**ZONING BOARD OF APPEALS APPLICATION**

**Project Name, If Applicable:** Aviles Residence

Re: Letter of Principle Points, Area Variance Request for:  
87 Kensington Rd Bronxville NY; SBL: 23.16/22; Application#: ALT 074-24:

**PLAN REVIEW COMMENTS**

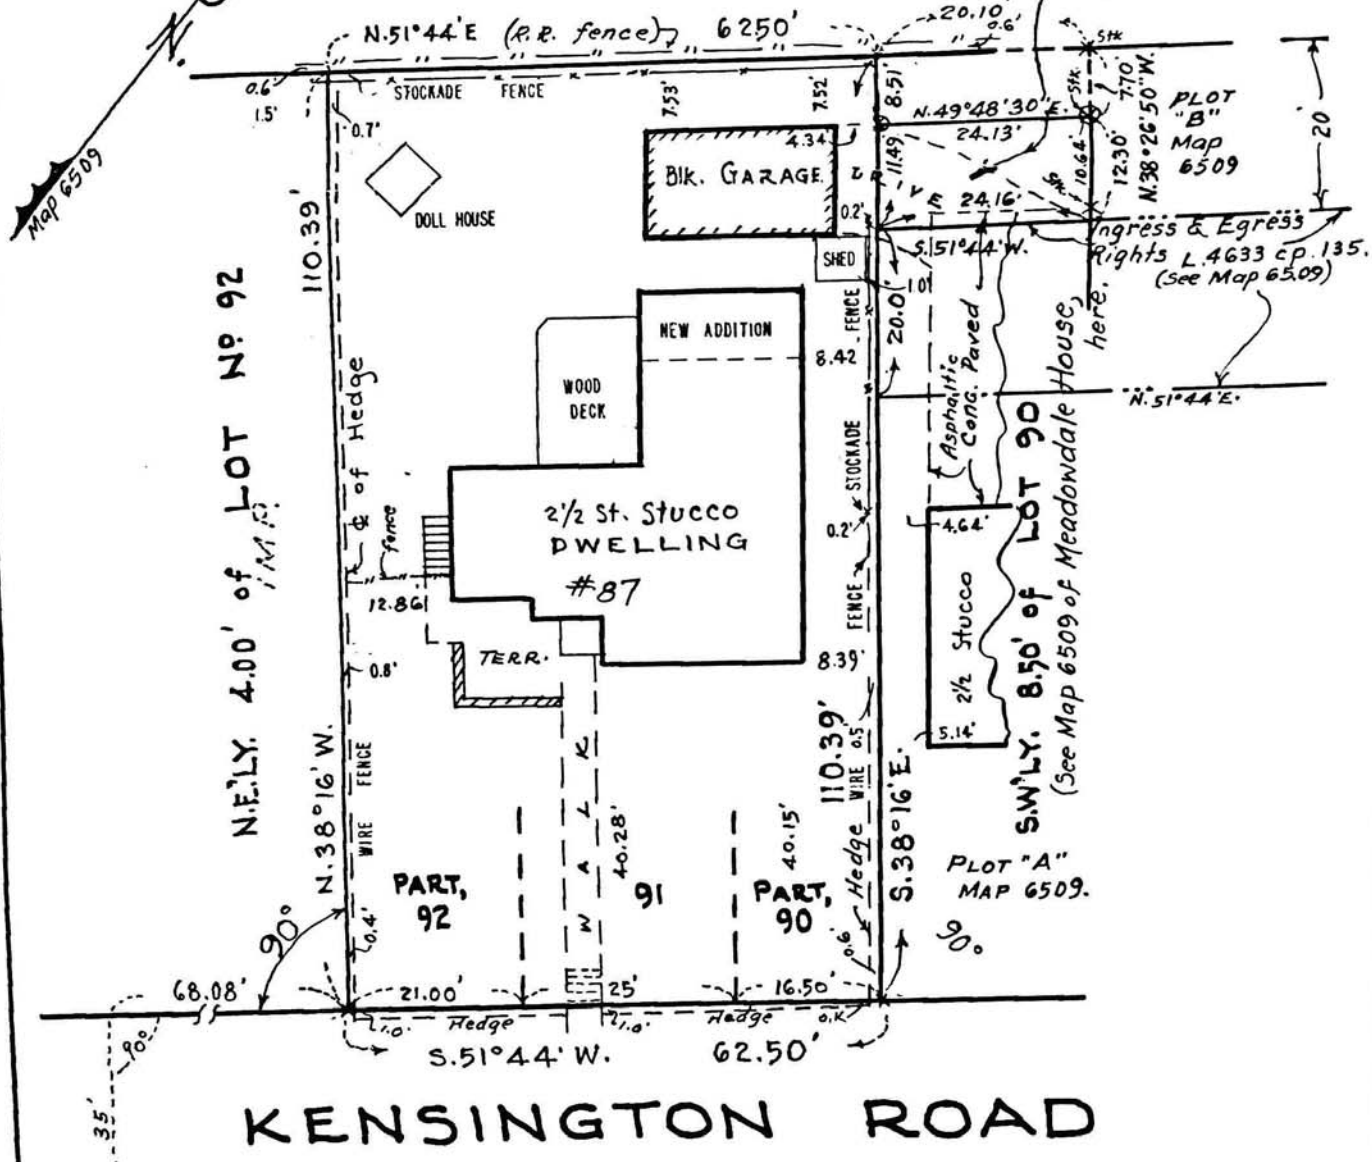
- 1) As per 310-11J - ..."No parking space shall be located in any front yard".. - proposed new parking space requires a variance - installation of a parking space in the front yard.
- 2) As per 310- 22 D Parking in front yards prohibited in residential districts. ...not permitted within front yard..In addition, all driveways shall be setback at least 3 feet from any side yard lot line... Variance is required for parking in front yard and for less than 3 feet to the side yard lot line.
- 3) As per 310-11D 4 (a) - fence and walls - maximum combined height - 6-1/2' proposed 7'. variance required - 6" for fence wall height.
- 4) 310-11D 4(a) - fence and walls - required to be not more than 1/2 solid – stone retaining wall requires a variance.

- 1) Complete drainage plan required to be submitted by NY State Licensed Engineer.  
\$1000.00 fee required for village consulting engineer review.
- 2) All drywells required to be a minimum 10' from any lot line, building.
- 3) Tie into public storm sewer system is not allowed.
